PLANNING COMMISSION AGENDA

Meeting Date – August 17, 2016

CASE NUMBER: DP-16-0251

Planning Commission
Meeting Date – August 17, 2016
CASE NUMBER: DP-16-0294
Case Manager: Frank G. Breaux, AICP

SITE PLAN

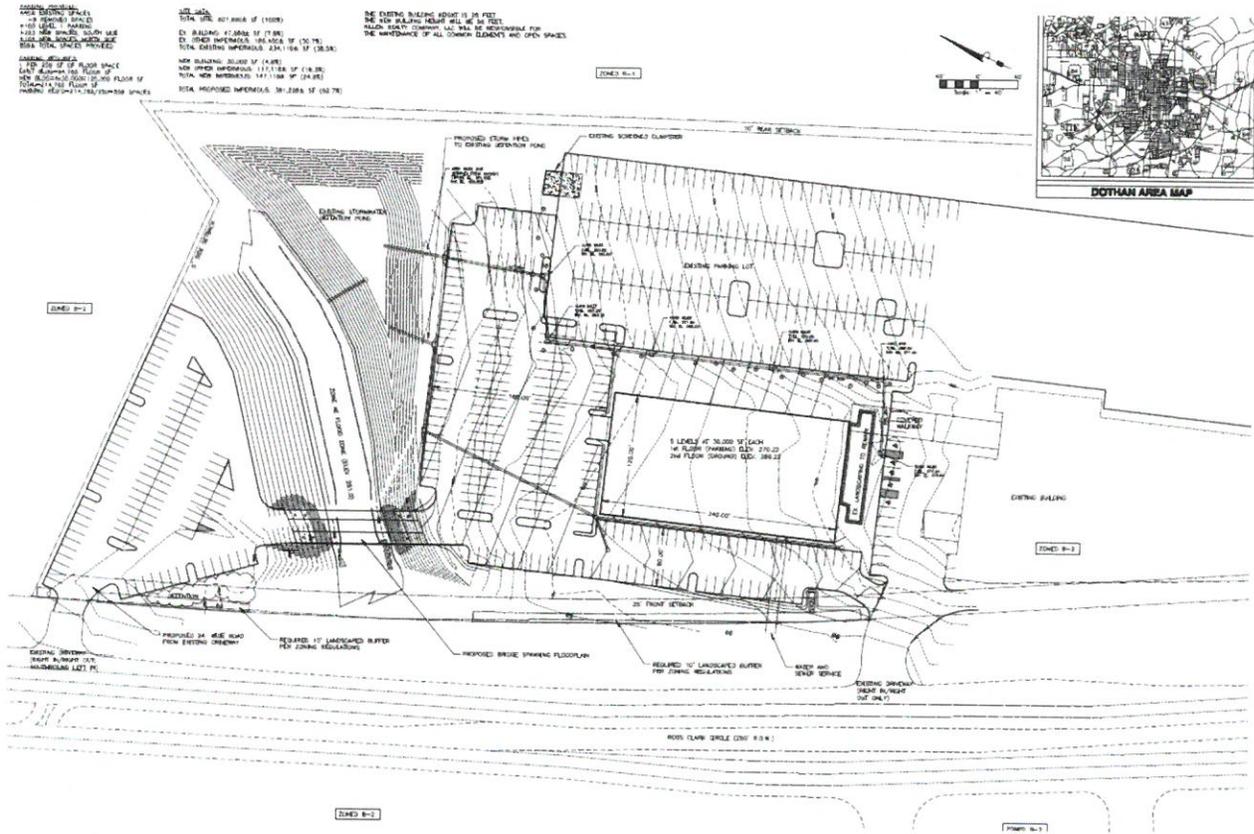
Required parking for the new building is 480 spaces based upon its classification as mixed use. The existing building, however, is entirely dedicated to medical offices and thus requires 631 spaces for a total of 1,111 required parking spaces. This is not consistent with the calculations provided on the plan which states that there are only 859 required parking spaces. The resulting deficit is 252 spaces which must either be provided on site or varied by the Board of Zoning Adjustment. In addition, Sec 114-238.H.2. states that no more than fifteen (15) parking spaces shall be permitted in a continuous row, excluding spaces fronting buildings, without being interrupted by an interior planting area. The plans must be modified to correct this deficiency.

Parking:

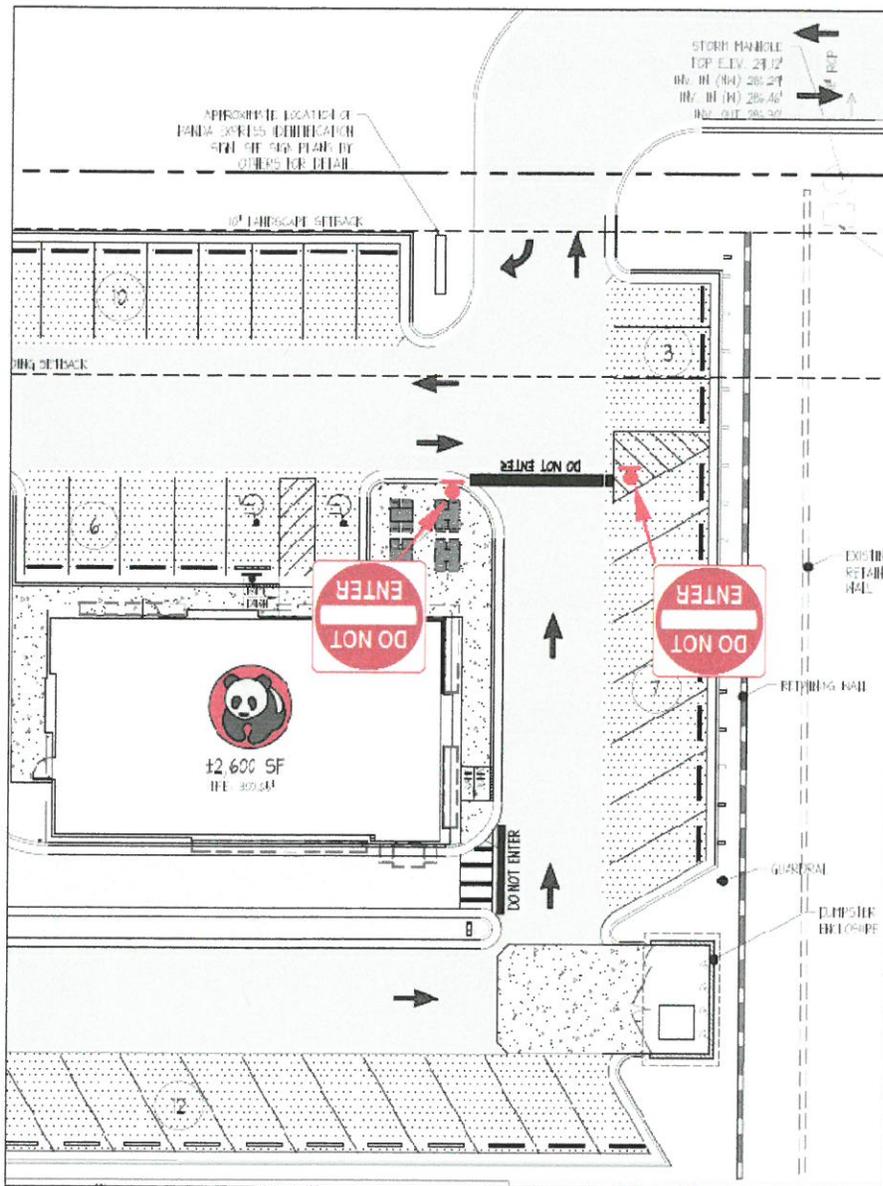
The site plan states that 62 parking spaces are required which is not correct. Parking for fast food restaurants is 1 space per 40 square feet of public area plus one space per employee on the greatest shift. An accurate calculation must be shown on the plan indicating compliance with this standard. Queueing for three (3) vehicles is also required from the menu board order station. The plan reflects a queue of two (2) and must be corrected. Otherwise, the parking and circulation plan is satisfactory.
